Revisions			WFILS		Project	***				
Date:	Rev:	Details:	MACKERETH ARCHITECTS 5e SHEPHERD STREET MAYFAIR LONDON WIJ 7HP TELEPHONE +44 (0)20 7495 705			Drawing Title Proposed SB Service Li ROOM 2 Scale Creation Date				
			Info	Project No. 404		Drawing No. 402		Revision		
				Date: Rev. Details: WELLS MACKER ARCHITECTS Se SHEPHERD ST MAYFAIR LONDON WIJ 7H TELEPHONE +44 EMAIL: HQ@WELL Status	Date: Rev: Detaits: WELLS MACKERETH ARCHITECTS Se SHEPHERD STREET MAYFAIR LONDON WIJ 7HP TELEPHONE +44 (0) 20 7495 7055 EMAIL: HQ@WELLSMACKERETH.COM	Date: Rev. Details: WELLS MACKERETH ARCHITECTS Se SHEPHERD STREET MAYFAIR LONDON W 1 J 7 HP TELEPHONE +44 (0) 20 7 495 7055 EMAIL: HQ@WELLSMACKERETH.COM Status Project No.	Date: Rev. Details: WELLS MACKERETH ARCHITECTS Se SHEPHERD STREET MAYFAIR LONDON W 1J 7 HP TELEPHONE +44 (0) 20 7 495 7 055 EMAIL: HQ@WELLSMACKERETH.COM Slatus Project No. Drawing No. Drawing No.	Date: Rev: Details: WELLS MACKERETH ARCHITECTS 5 e SHEPHERD STREET MAYFAIR LONDON W J J 7HP TELEPHONE + 44 (0) 20 7 49 5 7055 EMAIL: HQ@WELLSMACKERETH.COM Status Project No. Drawing No.

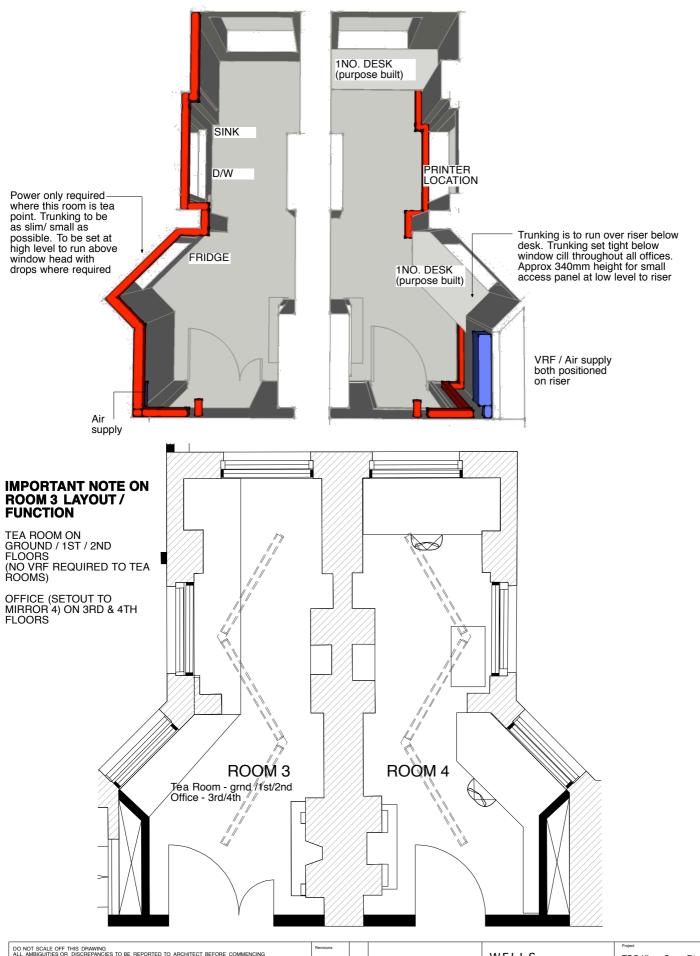
DO NOT SCALE OFF THIS DRAWING ALL AMBIGUITIES OR DISCREPANCIES TO BE REPORTED TO ARCHITECT BEFORE COMMENCING Notes NOTE: Where trunking continues over riser:	Date:	Rev:	Details: Trunking route revised as per EEP comment	WELLS MACKERE	TOG	G Kings Cr	oss E1		
Trunking should be set throughout all offices at right below window cill (around 590mm). This will allow approx. 340mm height between skirting and trunking to allow an				ARCHITECTS Se SHEPHERD STREET MAYFAIR LONDON W1J7HP TELEPHONE +44 (0)20 7495 7055 EMAIL: HQ@WELLSMACKERETH.COM			posed SB S OM 1) @ A4	Service Layout Creation Date Nov 2012	
access panel at low level to the riser				Info Project No. 404					A

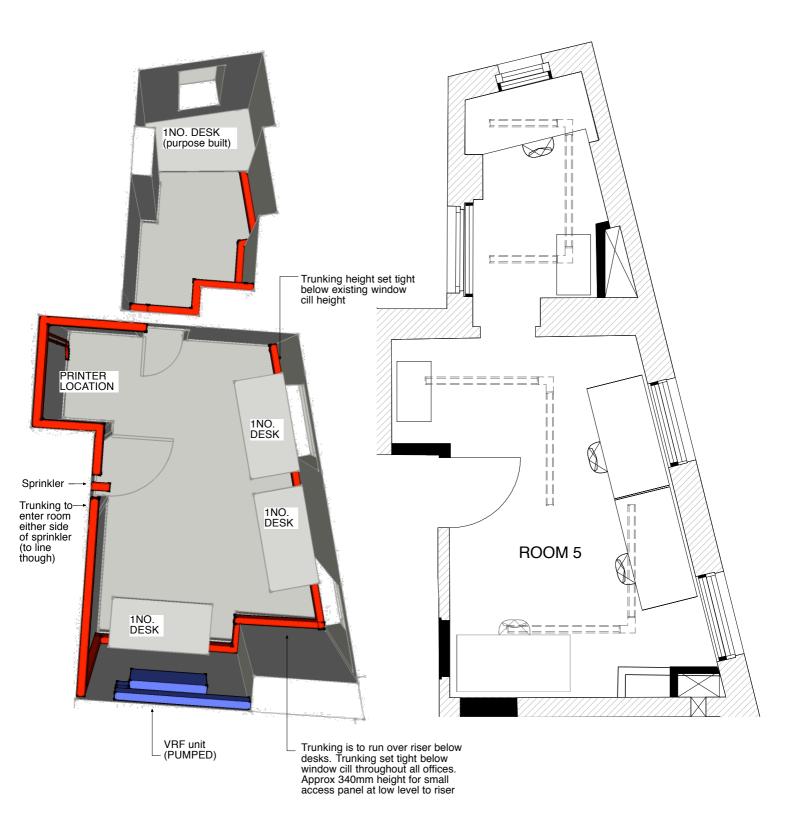
DO NOT SCALE OFF THIS DRAWING ALL AMBIGUITIES OR DISCREPANCIES TO BE REPORTED TO ARCHITECT BEFORE COMMENCING	Revisions			WELLS		TOO	G Kings Cr	oss E1	
NOTE: Where trunking continues over riser:	Date: 15.11.12	Rev: A	Details: Trunking route revised as per EEP comment	MACKERETH ARCHITECTS Se SHEPHERD STREET MAYFAIR LONDON WIJ 7HP			g Title		
Trunking should be set throughout all offices at right below window cill (around 590mm).							posed SB 3 OM 3 & 4	SB Service Layout & 4	
This will allow approx. 340mm height between skirting and trunking to allow an				TELEPHONE +44 (0) 20 7495 7055 EMAIL: HQ@WELLSMACKERETH.COM		1:50	0 @ A4	Nov 2012	2
access panel at low level to the riser				Status	Project No.		Drawing No.		Revision
				Info	404		403		Α

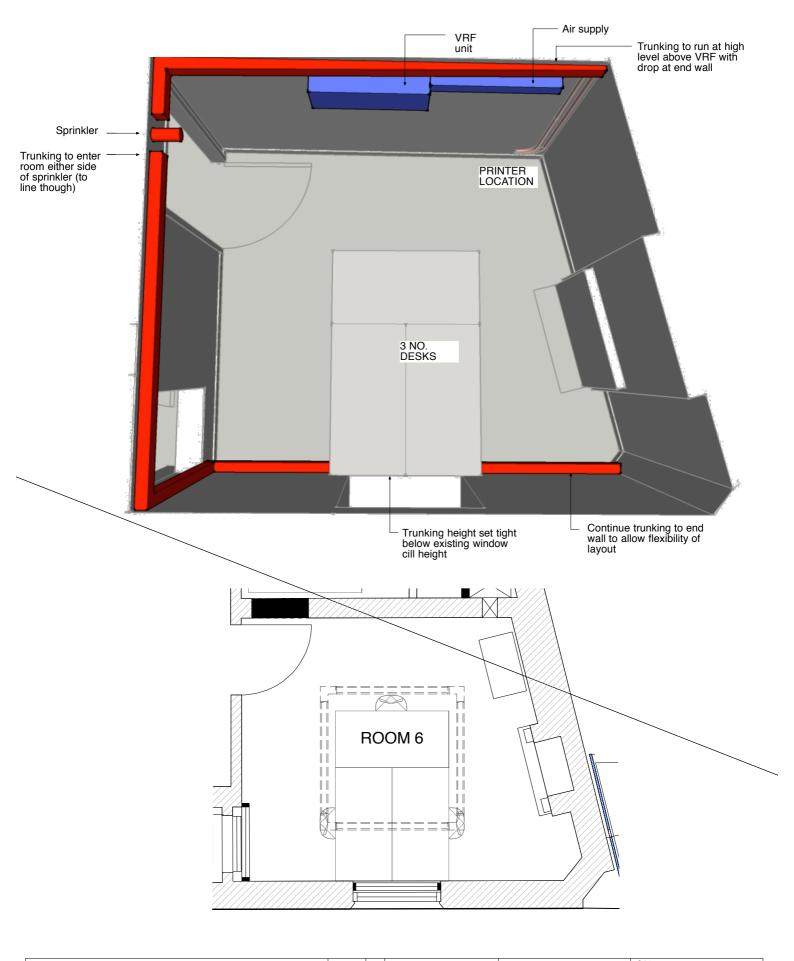
DO NOT SCALE OFF THIS DRAWING ALL AMBIGUITIES OR DISCREPANCIES TO BE REPORTED TO ARCHITECT BEFORE COMMENCING	Revisions		WELLS		TOG	G Kings Cros	ss E1	
NOTE: Where trunking continues over riser: Trunking should be set throughout all offices at right below window cill (around 590mm). This will allow approx. 340mm height between skirting and trunking to allow an	Date: 15.11.12	Details: Trunking route revised as per EEP comment	MACKERETH ARCHITECTS Se SHEPHERD STREET MAYFAIR LONDON WIJ 7HP TELEPHONE +44 (0)20 7495 7055 EMAIL: HQ@WELLSMACKERETH.COM		RO	posed SB Se	ervice Lay	
access panel at low level to the riser			Info	Project No.		Drawing No.		A

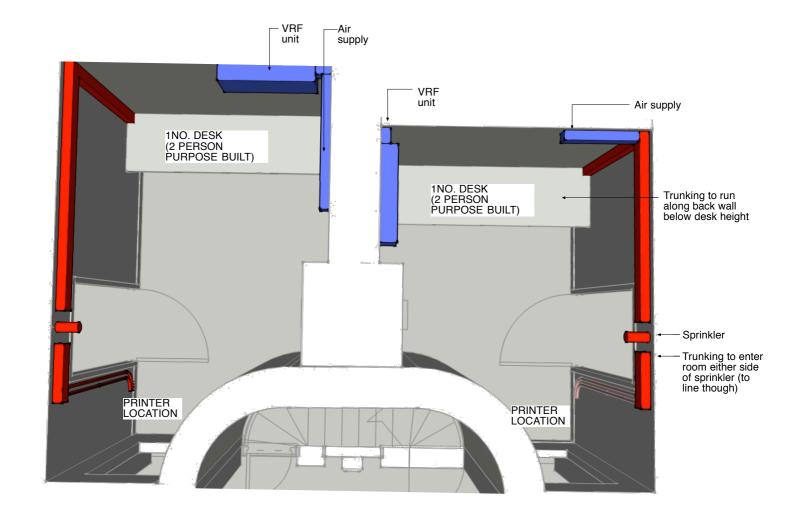
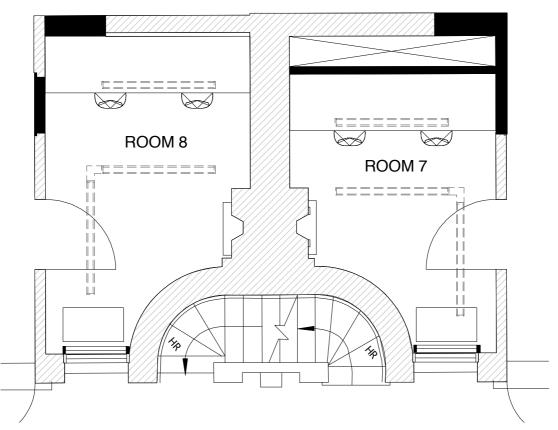
DO NOT SCALE OFF THIS DRAWING ALL AMBIGUITIES OR DISCREPANCIES TO BE REPORTED TO ARCHITECT BEFORE COMMENCING	Revisions			WELLS			G Kings Cro	oss E1	
NOTE: Where trunking continues over riser: Trunking should be set throughout all offices at right below window cill (around 590mm). This will allow approx. 340mm height	Date: 15.11.12	Rev:	Details: Trunking route revised as per EEP comment	MACKERETH ARCHITECTS Se SHEPHERD STREET MAYFAIR LONDON W1J 7HP TELEPHONE +44 (0) 20 7495 7055 EMAIL: HQ@WELLSMACKERETH.COM Status Proper No. 404		RO	oosed SB S OM 7 + 8		
between skirting and trunking to allow an access panel at low level to the riser							Drawing No. 406		A
